**Zoning Board of Appeals Meeting of August 12, 2026**

**Application No. PUD-2026-012 GDP & SIP**

**Location:** 13750 Metric Road (04-16-326-003)

**Requested Actions:** PUD, Planned Unit Development for the construction of a new building to expand the existing museum use.

## Concept Plan / General Development Plan (GDP)

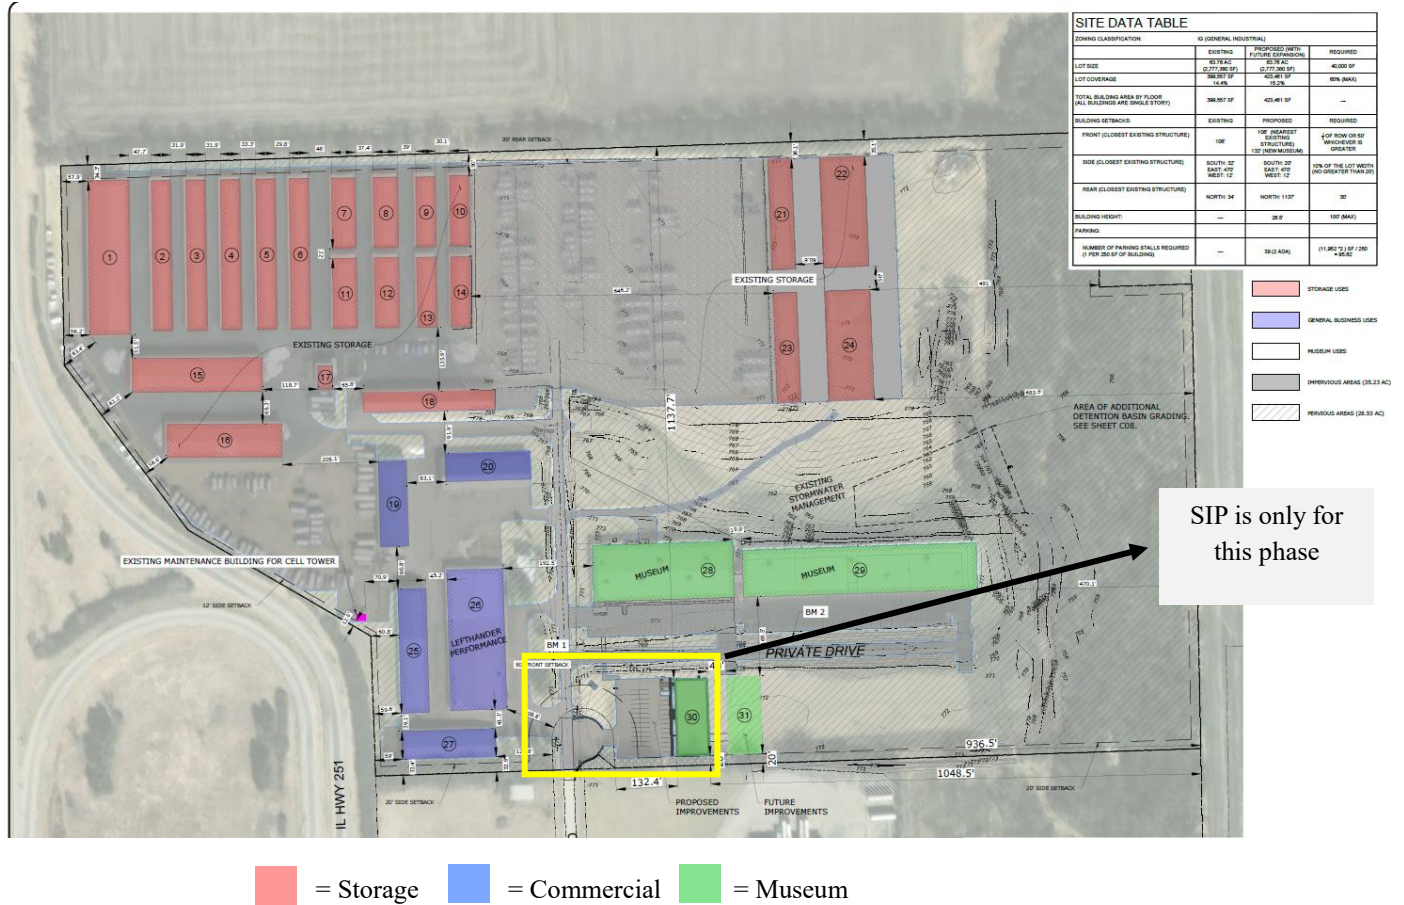
The subject property currently contains 29 buildings. The applicant is proposing the construction of Building 30, which will serve as a Fire Truck Museum. The General Development Plan (GDP) also identifies a future Building 31, located behind Building 30, as a planned museum addition. Building 31 is not included in the current Specific Implementation Plan (SIP) request.

Building Elevations

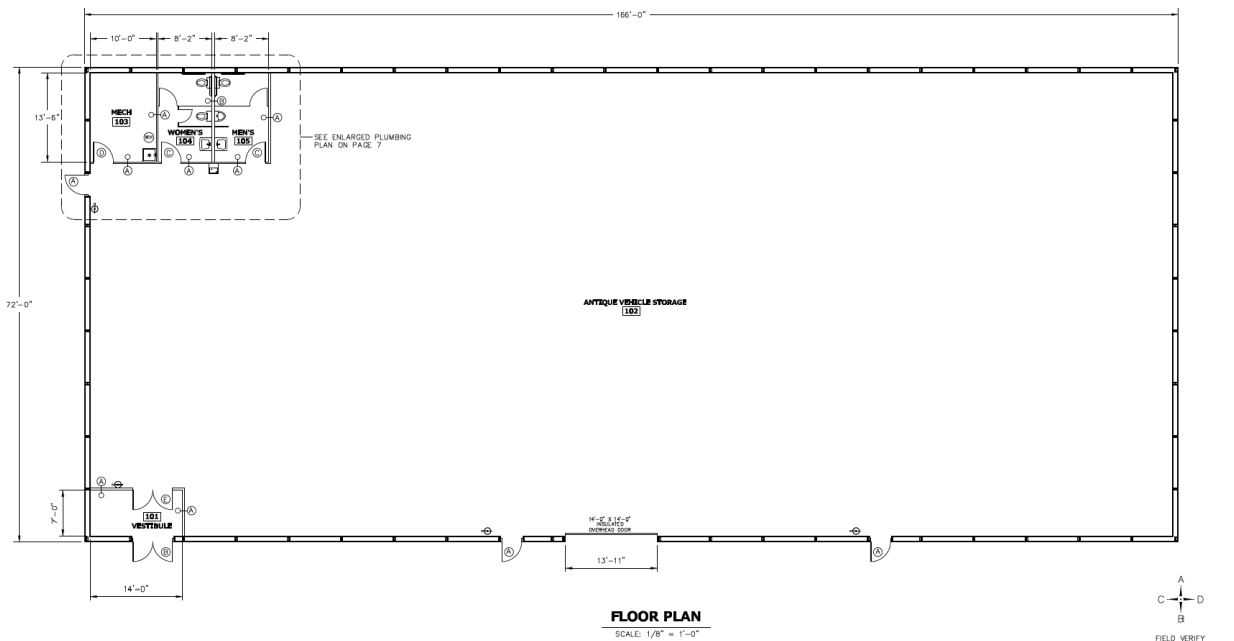
**Building Design (no change):** The proposed elevations indicate that the exterior will feature Max-Rib II steel panel siding in a light stone color, accented by a 3-foot steel wainscot trim in Tudor Brown, and will be constructed on a concrete slab. The color palette is designed to complement and align with the existing museum's aesthetic. The building's location meets the IG zoning setback requirements and complies with height regulations, as the proposed height of 26.5 feet is well below the maximum allowed.

Proposed Site Plan

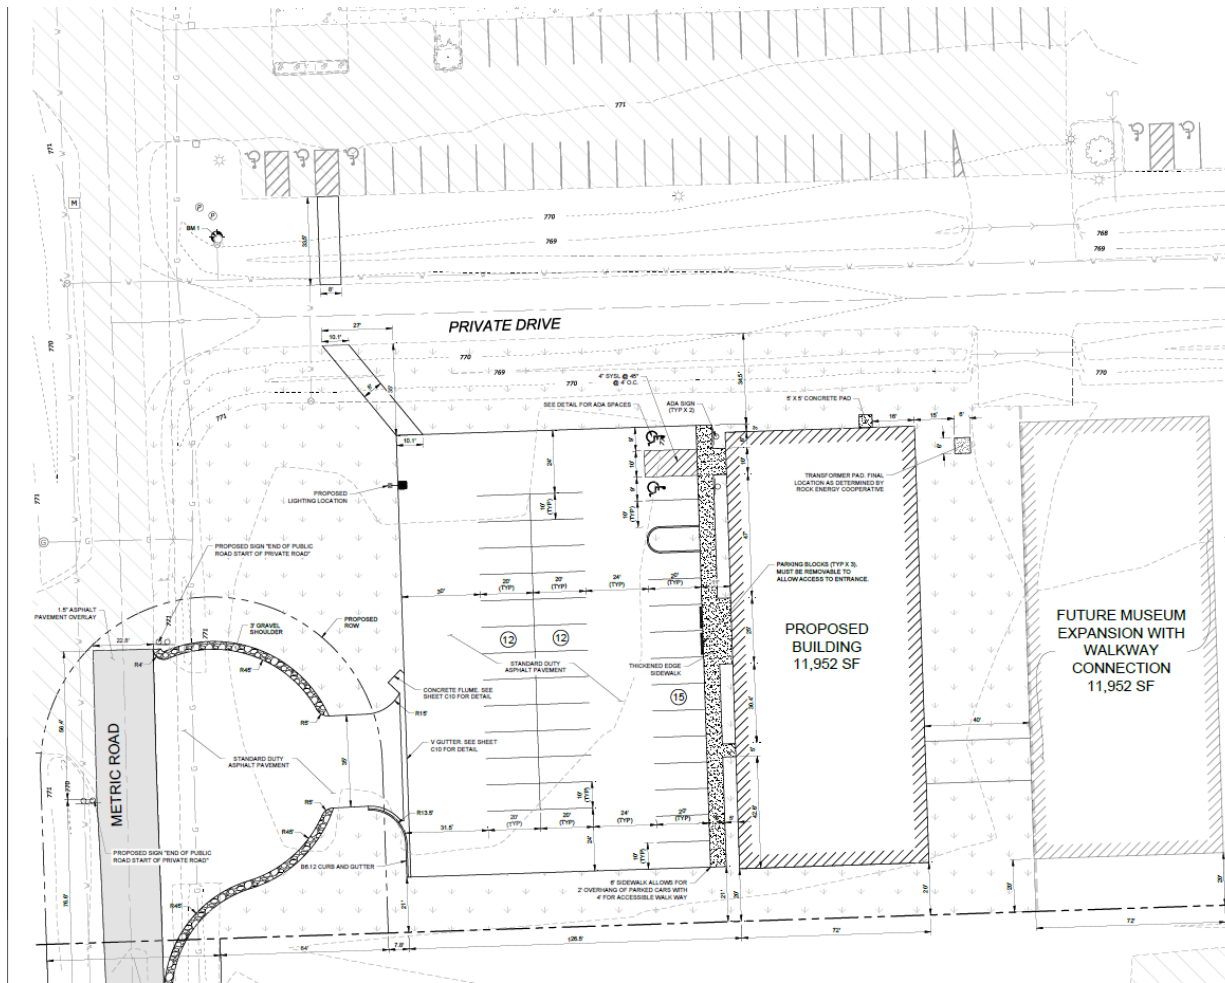
**Parking Lot Design and Layout:** Access to the site will be provided from Metric Road and a new dedicated cul-de-sac, in compliance with the annexation agreement. Wheel guards are required for parking spaces adjacent to sidewalks, pedestrian circulation areas, or landscape areas so that no part of a parked vehicle will encroach, but are not required for interior stalls. The applicant has asked to thicken the sidewalk along the front facade of the building instead of providing wheel stops. Engineering has agreed that this meets the intent of the code.

The proposed parking lot will be surfaced with asphalt, and the parking stall dimensions and drive aisles comply with the Zoning Ordinance. The parking stall width has been increased from 9.5 feet to 10 feet, and the drive aisles range from 24 feet to 31 feet in width, meeting and exceeding applicable code requirements. The reduction in paved area and corresponding increase in setback areas do not create any zoning compliance issues and are consistent with the requirements of the Code.

Pavement surface striping should define each parking space, and shall be a minimum of four inches in width from the length of each space. Striping for each parking space shall be painted yellow or white. Thermoplastic pavement markings are an acceptable alternative. A 5-foot-wide concrete pedestrian access has been added from the existing Museum parking lot to the new proposed parking lot to improve on-site circulation.

The updated plans removed two interior landscape islands, each measuring 9 feet by 18 feet, that were previously located along the ends of the continuous double rows of parking. The applicant is requesting flexibility from this requirement.

**Stormwater:** A stormwater management report was submitted for review. The report concludes the proposed basin discharge rate exceeds the maximum allowable release rate established by the Stormwater Management Ordinance. A revised stormwater management report is required to be submitted for review and approval by the Village Engineer.

1. The applicant shall obtain all required state, county, and local permits and approvals before commencement of work.
2. The applicant shall provide a thickened concrete sidewalk adjacent to the parking area along the front façade of Building 30 to serve as a durable vehicle stopping edge in lieu of wheel stops, as approved by the Village Engineer.

3. The parking lot shall be striped in full compliance with all applicable code requirements.
4. All proposed signage shall comply with the applicable sign regulations of the IG, General Industrial zoning district.
